## **QUESTIONS + ANSWERS**

6/2/23

TYPICAL THICKENED EDGE (TSE) N.T.S.

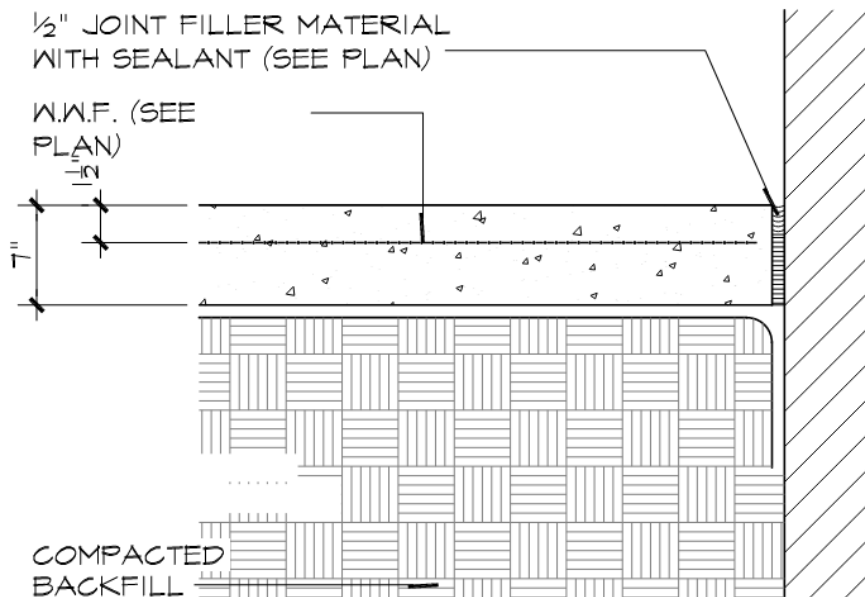
7. Demandstar "Q&A #2" - question #1: Sheet ASI.0 shows a square pattern which appears to be some type of hard surface. Please provide details, finish type.

**ANSWER: This is an exterior slab on grade. Refer to details included herein.**

DETAILS FOR ANSWER TO QUESTION #7 ABOVE
